Montana Department of Environmental Quality Comments on Phase I Site Characterization Data Summary Report; Columbia Falls Aluminum Company; Columbia Falls, Flathead County, Montana (February 27, 2017)

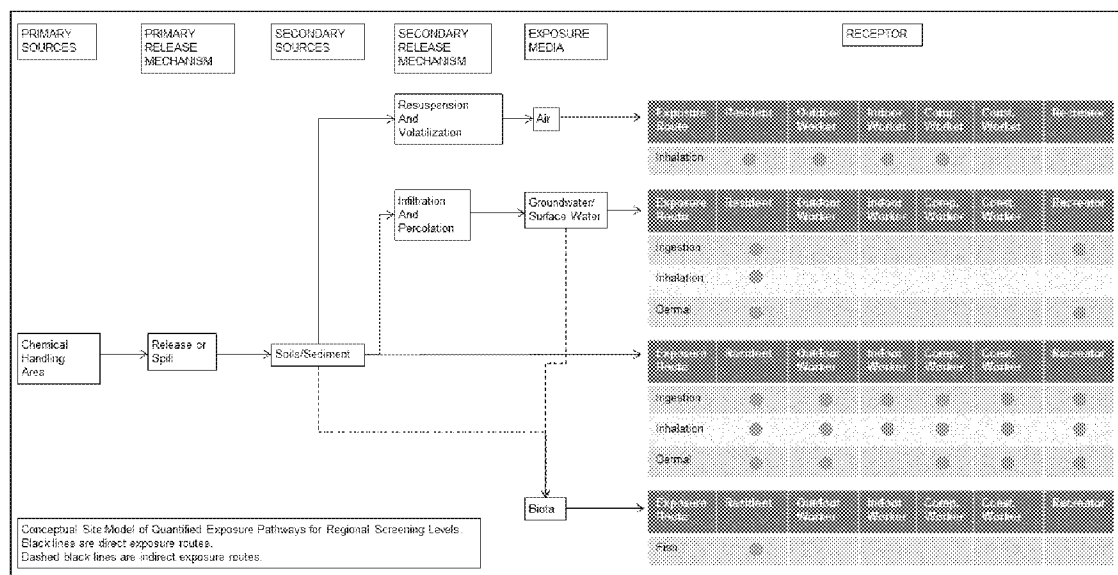
10.) Please add a figure showing an updated Conceptual Site Model for the site. This figure should include sources, affected medium, exposure points, exposure routes, and receptors. See the example figure below.
